**ALBERTA TRANSPORTATION SPRINGBANK OFF-STREAM RESERVOIR PROJECT
RESPONSE TO NRCB AND AEP SUPPLEMENTAL INFORMATION REQUEST 1, JULY 28, 2018**

Errata
May 2019

10 ERRATA

Distances of Tsut'ina Nation Boundary from Project Features

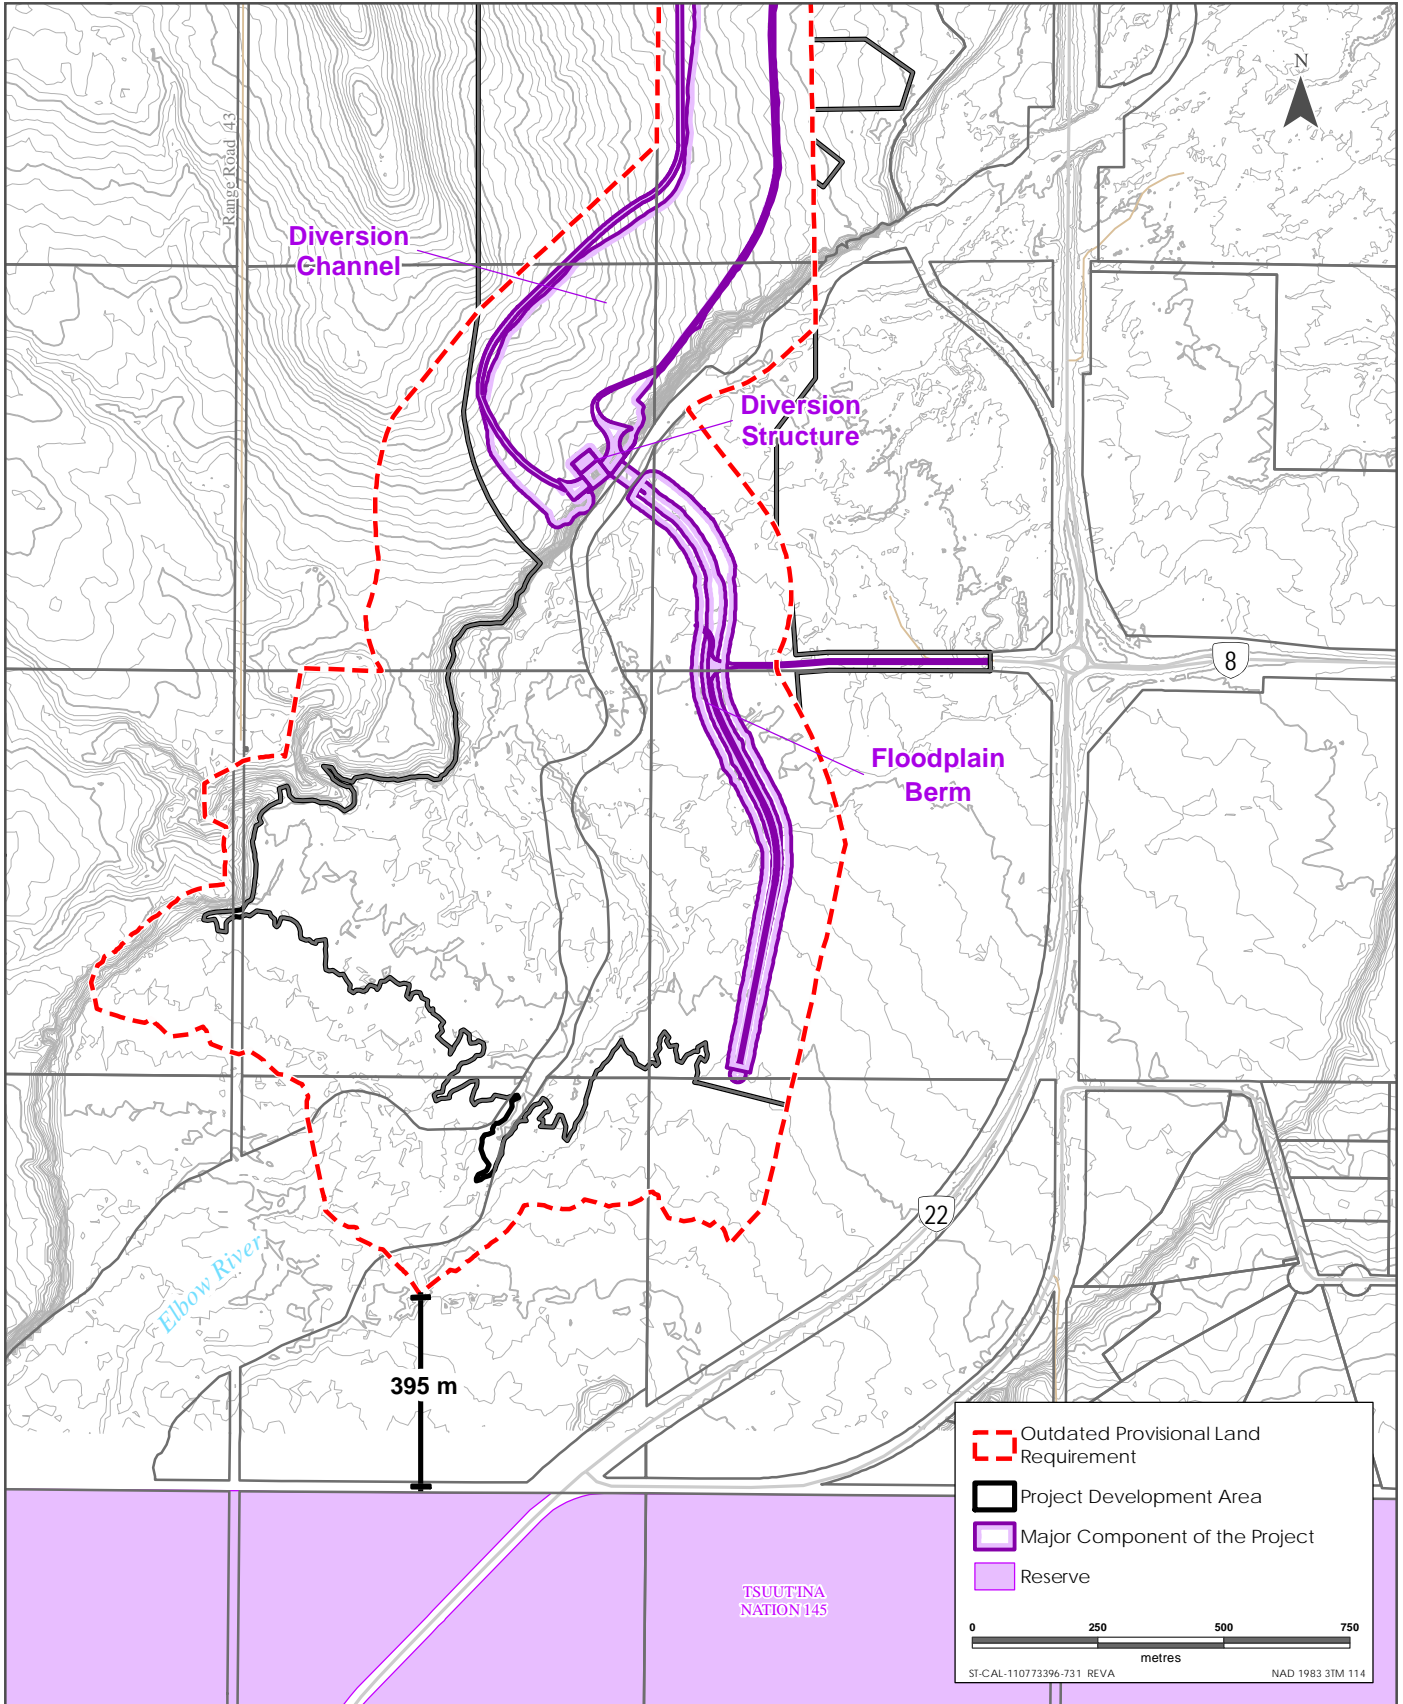
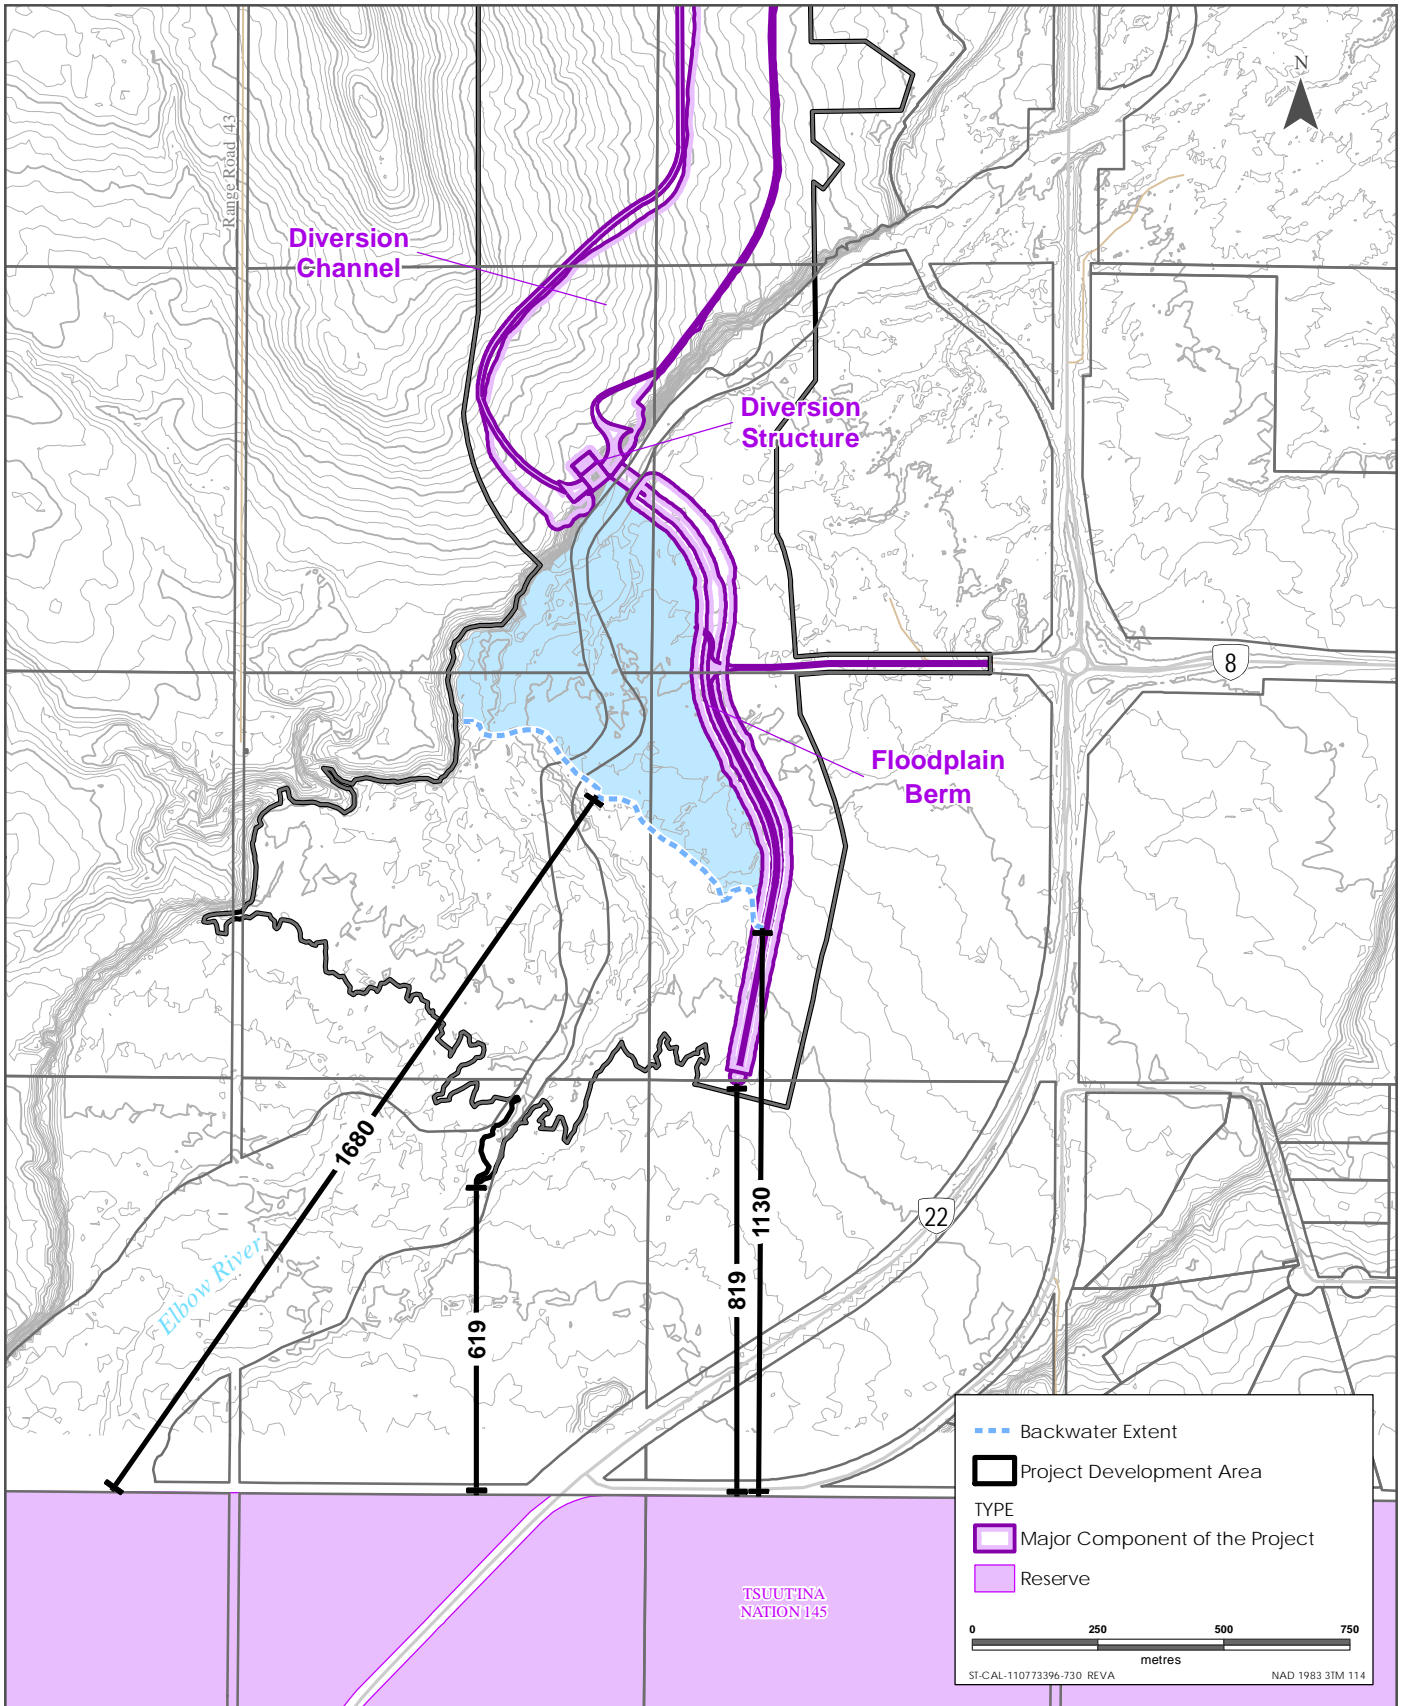
Section 1.3.1 states that Tsuut'ina Nation is located 619 m south of the southernmost part of the PDA. Whereas Table 7-3, Page 7.12 references a distance of 395 m in the first column but then states in the second column that the closest point of the Project to the Tsuut'ina Reserve is 930 m.

- a. Clarify the distance between the PDA and the Tsuut'ina Nation. Update the sections as required so that the correct distance is used.

- a. The 395 m distance is cited in the Project Description (Alberta Transportation 2016). Figure IR538-1 shows the outdated boundary of the Project (Provisional Land Requirement) that was used to calculate that distance. The initial Project design in March 2015 identified possible additional lands that might be needed for Project operation. Later revisions indicated that such lands were not necessary.

Figure IR538-2 shows the correct and different valid four distances of various Project features from the Tsuut'ina Nation Reserve. Each of these ways of measuring distances is used in the EIA and not only is the PDA referenced. The following is a description of these distances:

- 1,680 m is the distance along the Elbow River from the border of the Tsuut'ina Nation Reserve lands to the extent of the backwater in the event of a diversion of the design flood.
- 1,130 m is distance to backwater extent at the design flood; this is the same scenario as the 1,680 m distance, but it is not a possible flow path for water.
- 819 m is the distance from the closest Project structure (the terminus of the floodplain berm) to the border of the Tsuut'ina Nation Reserve lands.
- 619 m is the distance of Tsuut'ina Nation Reserve lands from the PDA

Location of Hound's Tongue

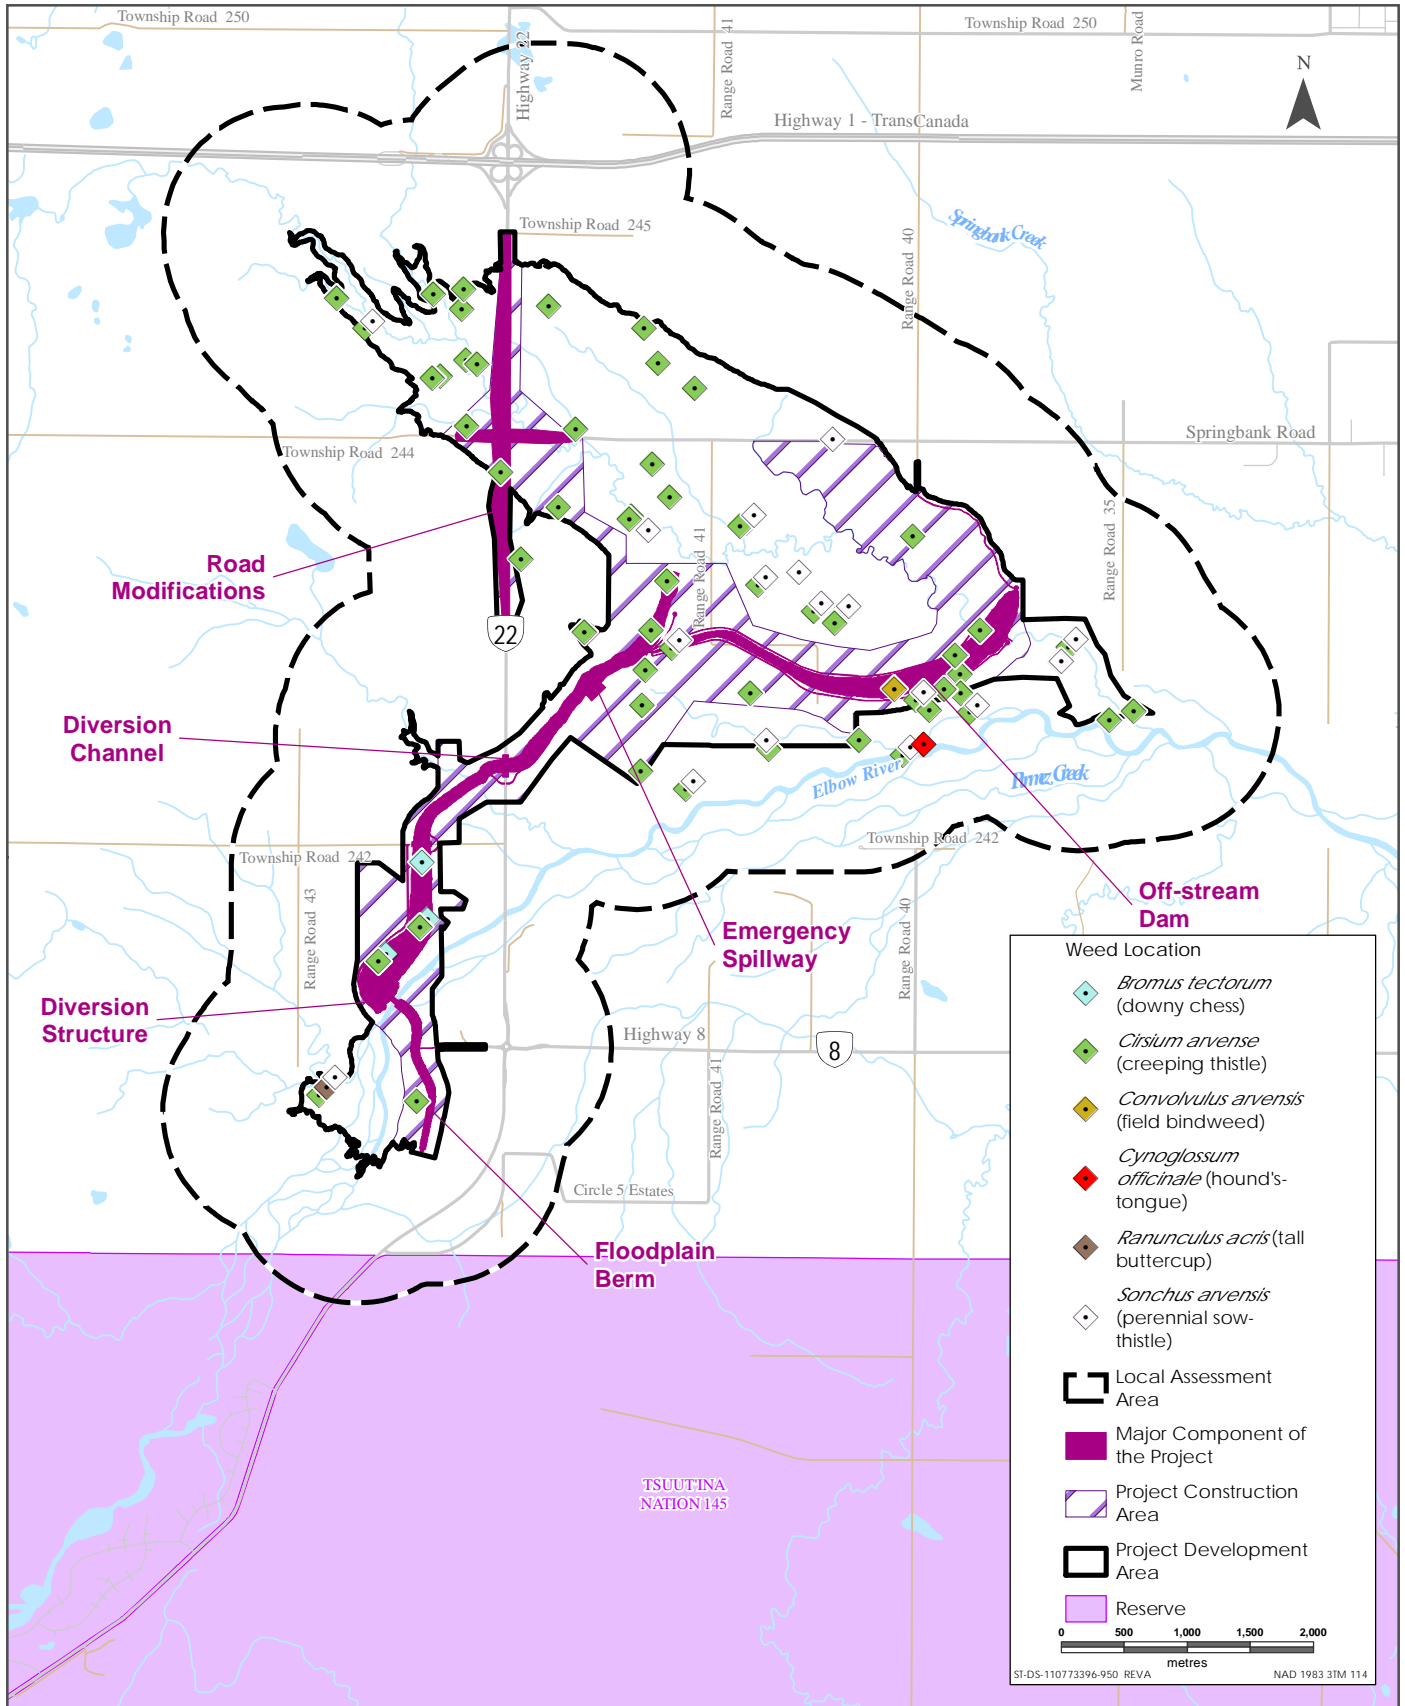
Reference is made to the presence of hound's tongue, but no point for this species can be located on Figure 10-5.

- a. Point out the presence of Hounds Tongue on Figure 10-5.

- a. Figure 10-5 in Volume 3A, Section 10 does not show the presence of hound's tongue. See Figure IR547-1 for the location of hounds tongue.

Figure IR553-1 Suspended Sediment Concentration in the Low-level Outlet and its Confluence with Elbow River for the 1:100 Year Flood (revision to Volume 3B, Section 6, Figure 6-20)

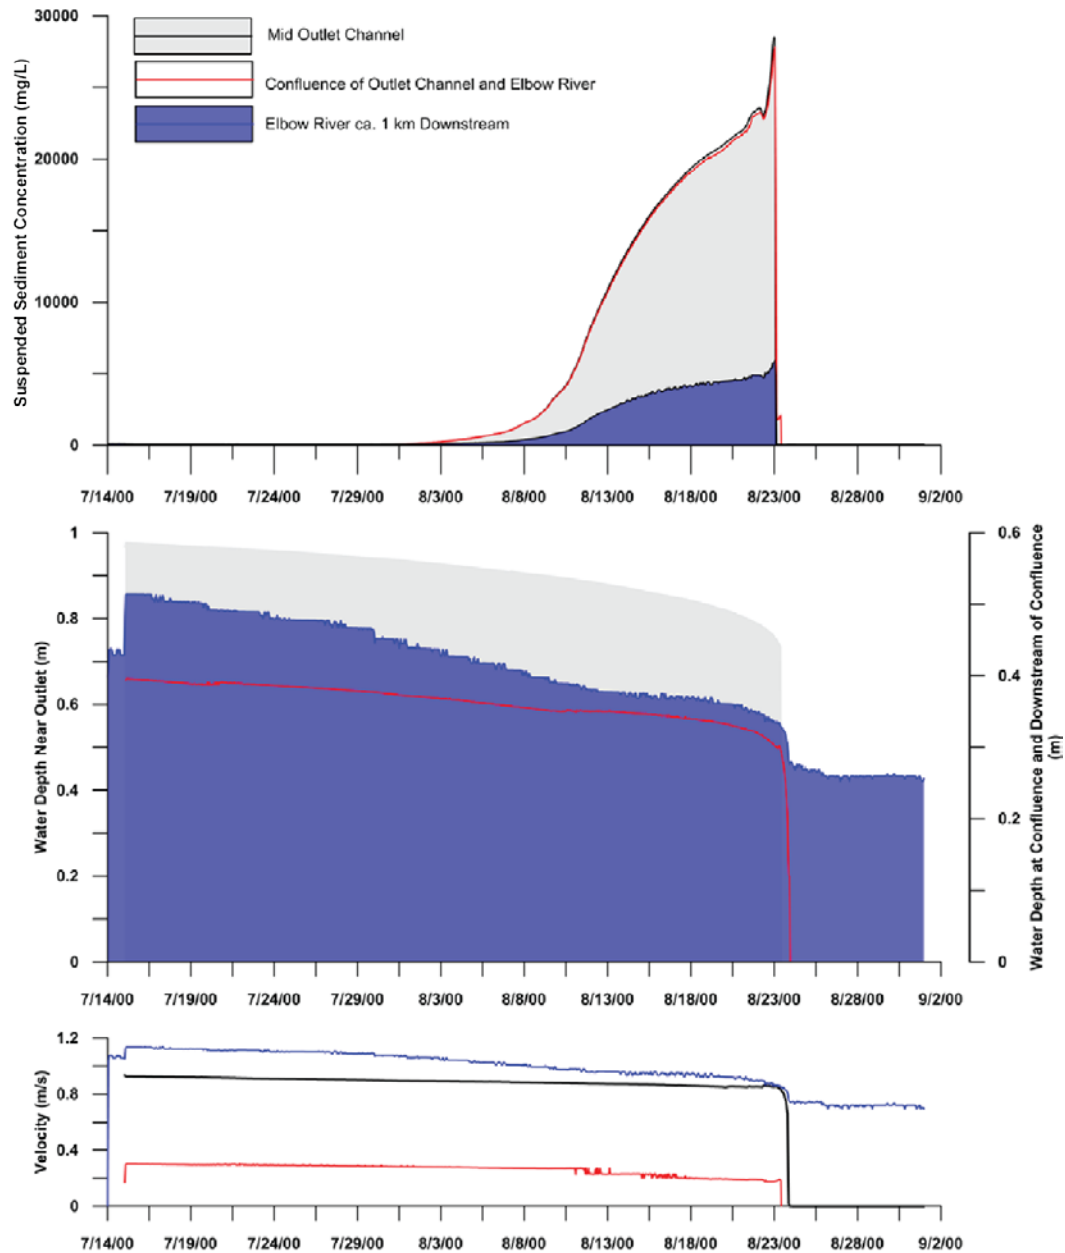
- a. Provide the y-axis label for the top plot of Figure 6-20 as it is missing.

- a. The y-axis should be labelled as follows: "Suspended Sediment Concentration (mg/L).

Figure IR553-1 is a revised version of Figure 6-20.

Figure IR577-1 Suspended Sediment Concentration, Discharge Rating Curves
 (additional information added to Volume 4, Appendix J, Figure 3-12)

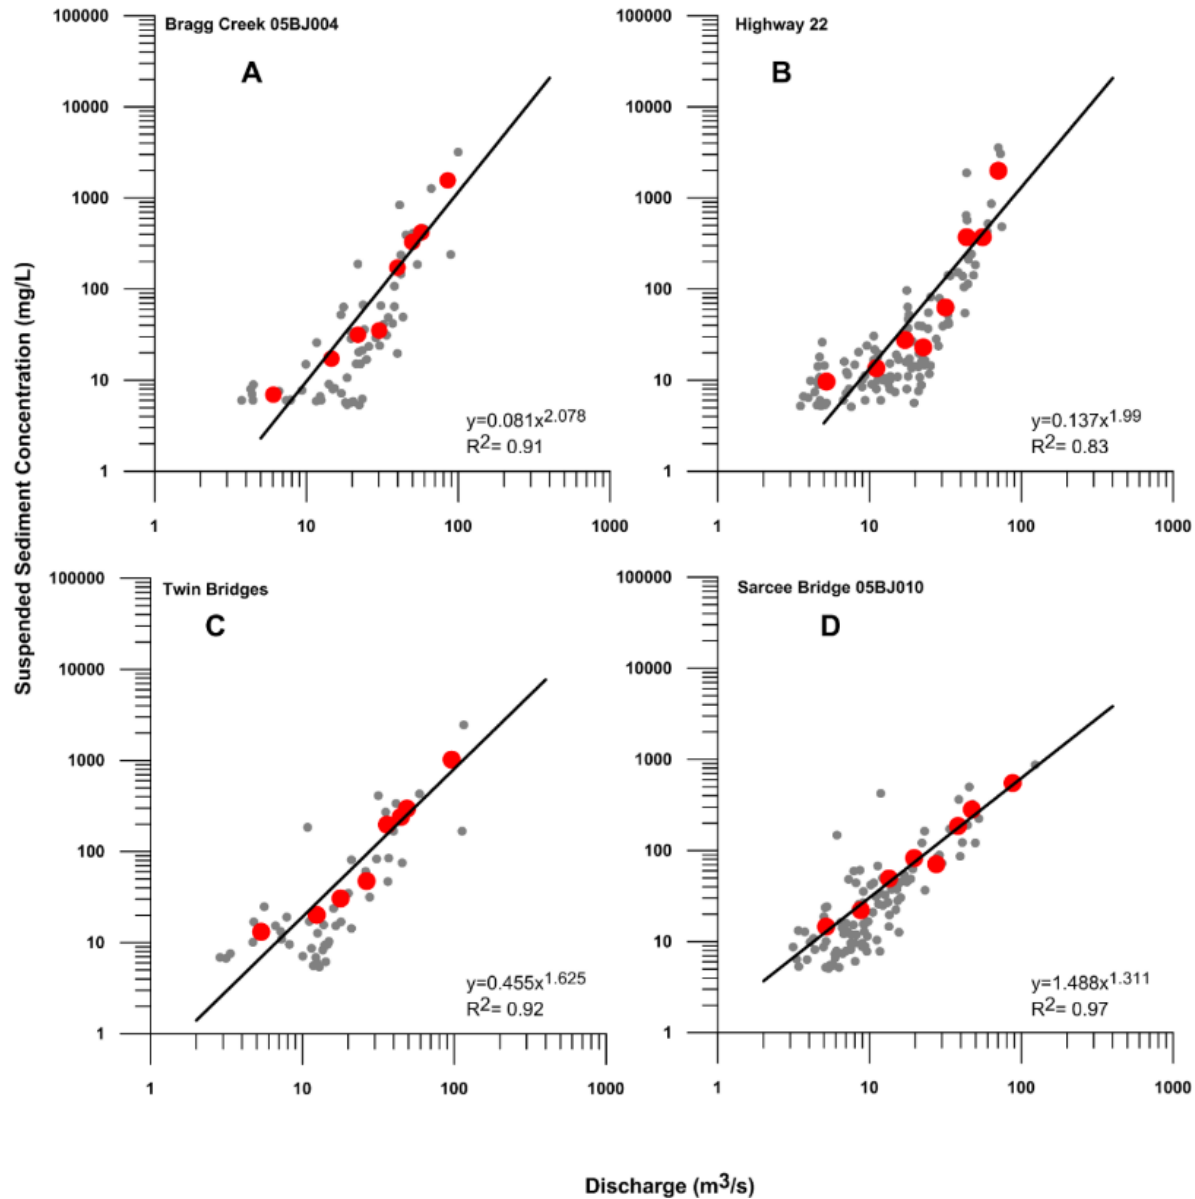
- a. Provide legends for the grey and red circles used in the plots.

- a. See Figure IR577-1 for the explanation of grey and red circles in Figure 3-12 and Figure IR577-2 for explanation of the same in Figure 3-14.

Red circle – Average suspended sediment concentration for associated average discharge rate (flow in Elbow River).
